Traffic Review of the Residential Development on Lucan Road, Dublin on behalf of GK Consulting Engineers

PMCE Ref:	P22-026-PSW1-RP-001
-----------	---------------------

Title: STAGE 1 ROAD SAFETY AUDIT

Hillhouse, Lucan, Proposed Residential Development.

Drawing P22-026-DG-SP-001 S0, Rev 2.0 – Disabled Parking Space.

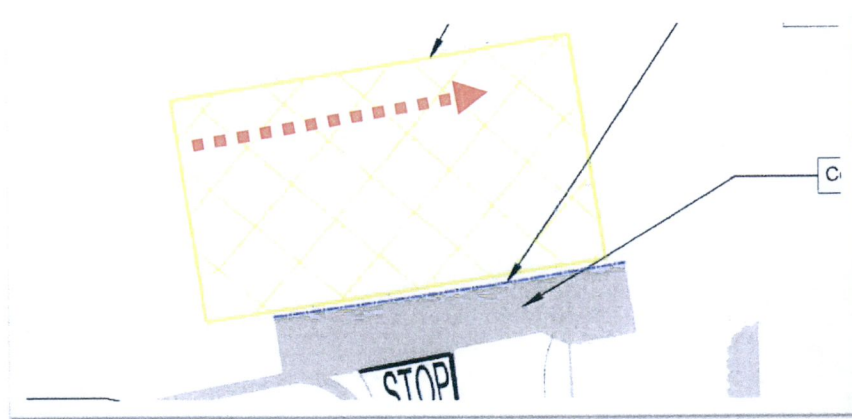
It is unclear if there is sufficient space for a user of the disabled parking space to easily enter/exit the parking space given the proximity of the boundary walls. A lack of space could lead to material damage of vehicles.

It is recommended that a swept path analysis be carried out to ensure that sufficient space is available.

Drawing P22-026-DG-VE-001 S0, Rev 2.0 – Visibility Splays.

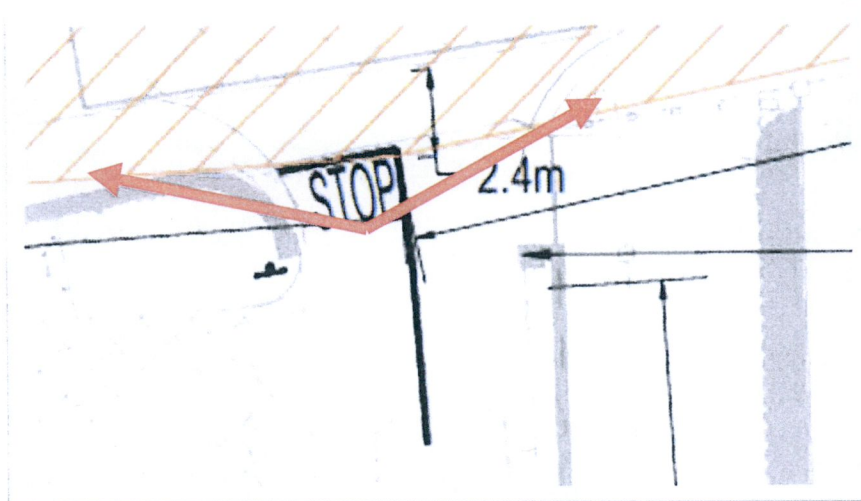
The proposed visibility splay lines cut through both existing and proposed obstacles (vegetation, walls etc.). These obstacles will obstruct visibility for drivers exiting the development and could lead to side-impact or rear-end collisions.

It is recommended that the visibility splays be kept clear of obstacles except for those that are momentary obstructions both individually and cumulatively.

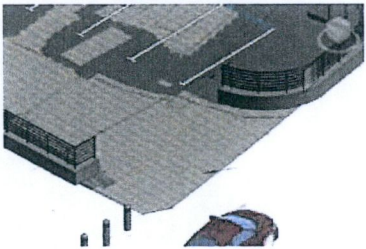
The proposed visibility for exiting drivers to crossing pedestrians on the footpath is not clear. The proposed boundary treatment may be high enough to block visibility to crossing children which could result in collisions with those pedestrians.

It is recommended that low boundary treatment be provided such that suitable inter-visibility is provided between exiting drivers and crossing pedestrians including small children.

Paragraph No. in Quality Audit Report	Problem accepted (yes/no)	Recommended measure accepted (yes/no)	Alternative measures (describe)	Alternative measures accepted by Auditors (Yes/No)
3.1	Yes	Yes		
3.2	Yes	Yes		
3.3	Yes	Yes		
3.4	Yes	No	<p>Attached below is an image of the (horizontal) railings proposed at the entrance for increased visibility. The Design team believe this will maintain adequate inter-visibility at the access.</p> 	Yes
3.5	Yes	Yes
